### Comfort Sync® Zoning System Wiring Change (Alert Code 120)

This bulletin applies to all Comfort Sync® control systems using Comfort Sync® Zoning System.

Product Information Bulletin

Figure 1. Comfort Sync Wi-Fi® and Comfort Sync® Zoning System

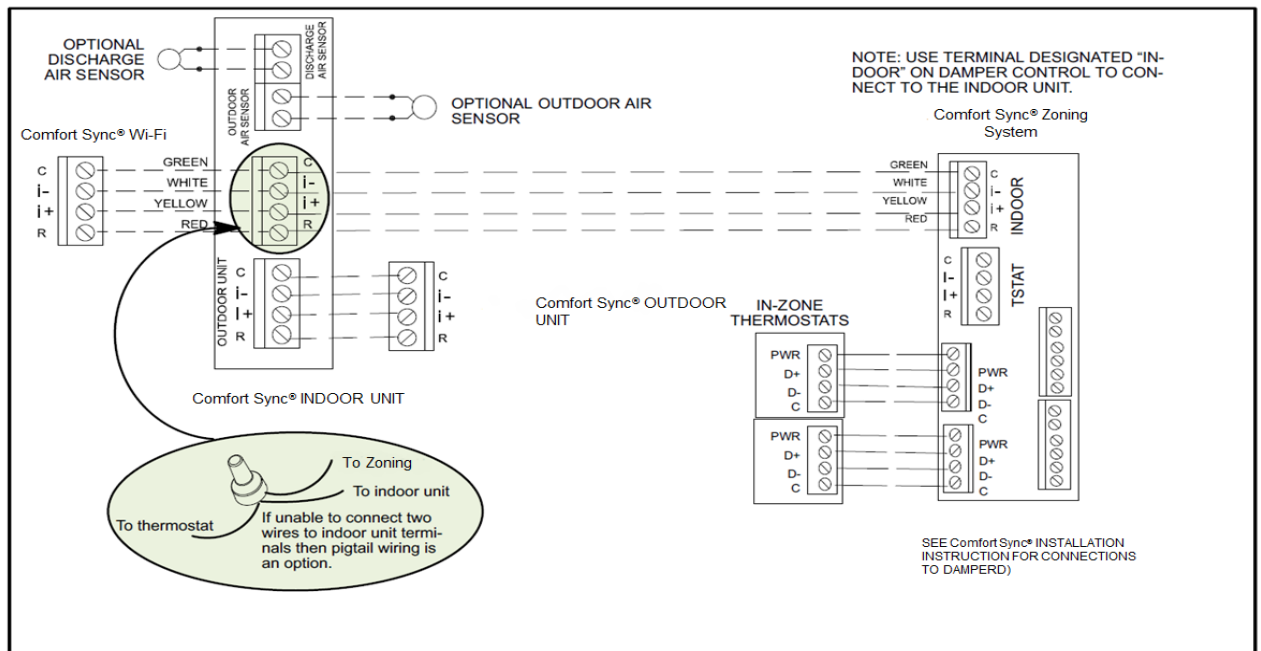
Alert Code 120 has been observed in systems using existing wiring methods recommended for the Comfort Sync® Zoning System. This issue has been duplicated in our test facility and a recommended change in the wiring method is required to reduce communication outages or delays between Comfort Sync® system components.

If an existing system has demonstrated this issue, then it is highly recommended to use the new wiring method. The system may still work using the original wiring method, however the new recommended method will decrease line interfere in communications. Using the new wiring method will also result in a more stable and efficient system. Refer to figure 1 for using the recommended new wiring method.

The new preferred wiring method is to:

- Connect either the Comfort Sync Wi-Fi® directly to the indoor Comfort Sync® unit.
- Connect the Comfort Sync® Zoning System control directly to the Comfort Sync® indoor unit.
